U.S. NUCLEAR REGULATORY COMMISSION
OFFICE OF INSPECTION AND ENFORCEMENT

Report No. 50-346/81-13

Facility Name: Davis-Besse Nuclear Power Station, Unit 1

Inspection Summary

FIGURE 1

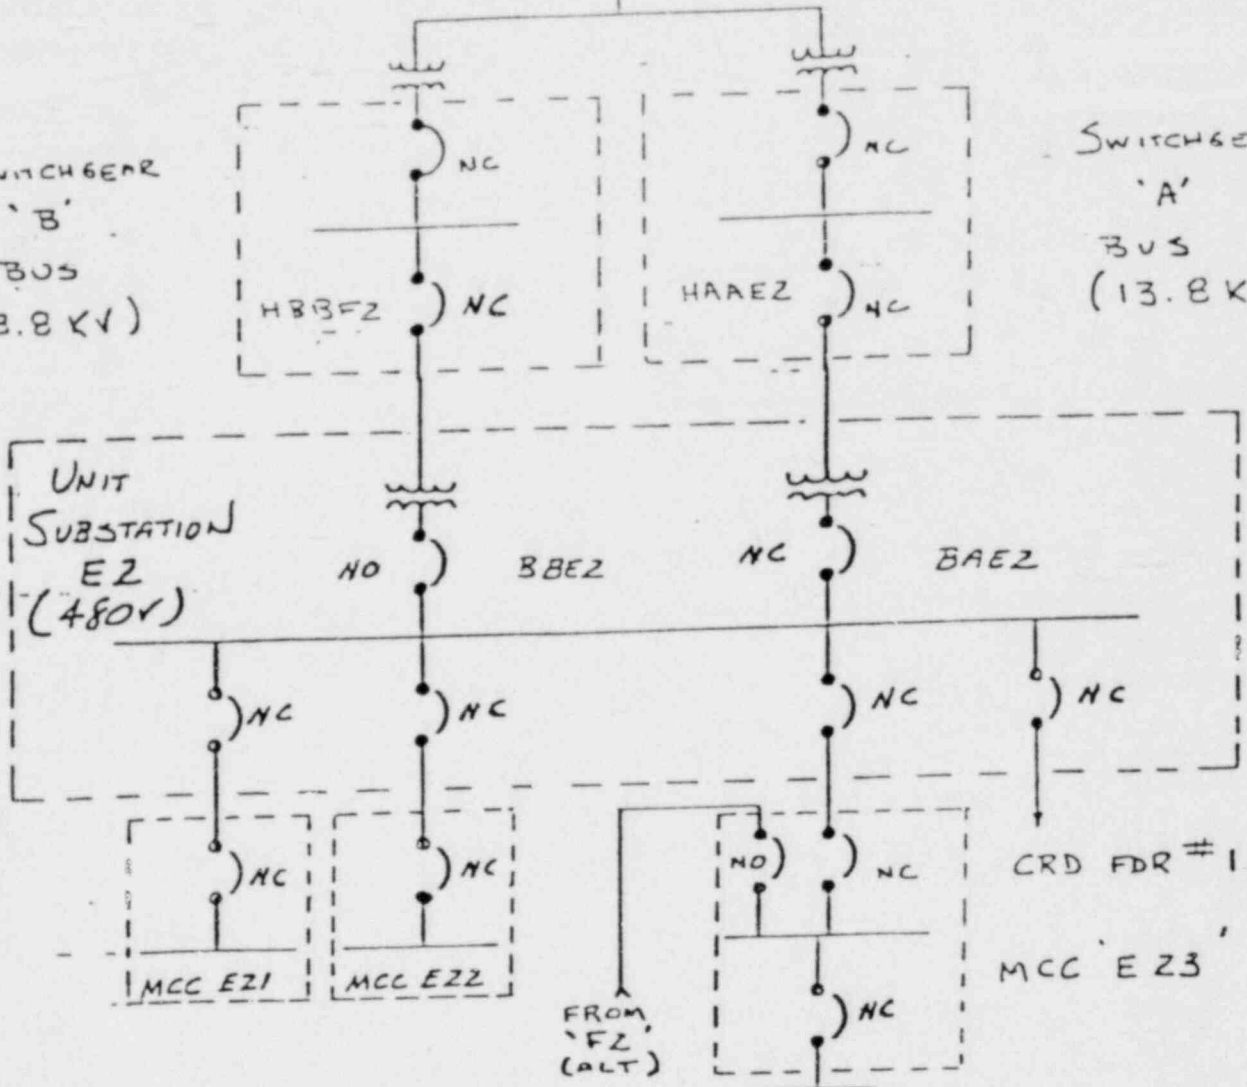
At approximately 1:27 p.m., construction personnel erecting scaffolding for Facility Change 80-137, inadvertently caused a mechanical shock to nonessential breaker NAAE2. The mechanical shock caused the ground fault relay to activate and trip the breaker.

The loss of E2 bus deenergized the power supply, E23, to the borated instrumentation distribution panel YAR which is the alternate supply to uninterruptible instrument power panel YAU. Since YAU was on its alternate supply, YAU was also deenergized.

The loss of power to YAU resulted in a loss of station annunciators, computer peripherals, both saturation meters, No. 2 bus for the control rod drive breakers, the diesel fire pump control panel and AC power to "Y" bus of non-nuclear instrumentation. The loss of power to the control rod drive breaker resulted in a reactor scram.
